## **Jacobs Exhaust Brake™ Service Letter X10**

**SUBJECT: Outlet gasket required for certain vehicle manufacturer installations**

**MODELS AFFECTED: EXISC Full-Marmon Turbo Mount**

**DATE: October 1, 1998**

Figure 1

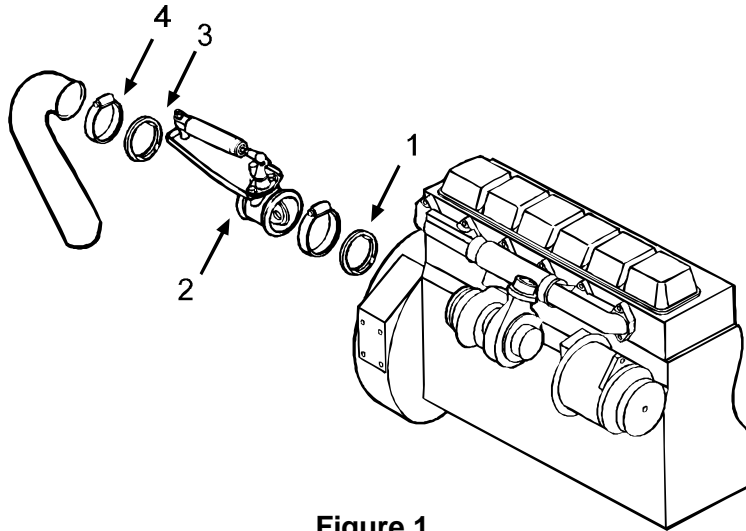
Refer to Figure 1 on the next page.

Whenever removing an exhaust brake assembly from an ISC turbo-mount model, determine whether there is a gasket (3) installed on the outlet side (2) of the brake assembly. If there is a gasket, this gasket must be replaced with a new gasket when the assembly is reinstalled. **NOTE:** The inlet side gasket (1) must also be replaced with a new gasket whenever the assembly is removed for service.

If there is NOT a gasket on the outlet side of the exhaust brake assembly, a new gasket should not be required. However, when the assembly is reinstalled, check the V-clamp (4) when it is tightened to make sure the ends of the clamp do not contact each other before the proper torque is applied to the clamp nuts. The correct torque for the clamp nuts is 70 - 80 lb-in. (8 – 9 N•m). If the ends of the clamp meet before the proper torque has been applied, a gasket is required in this joint.
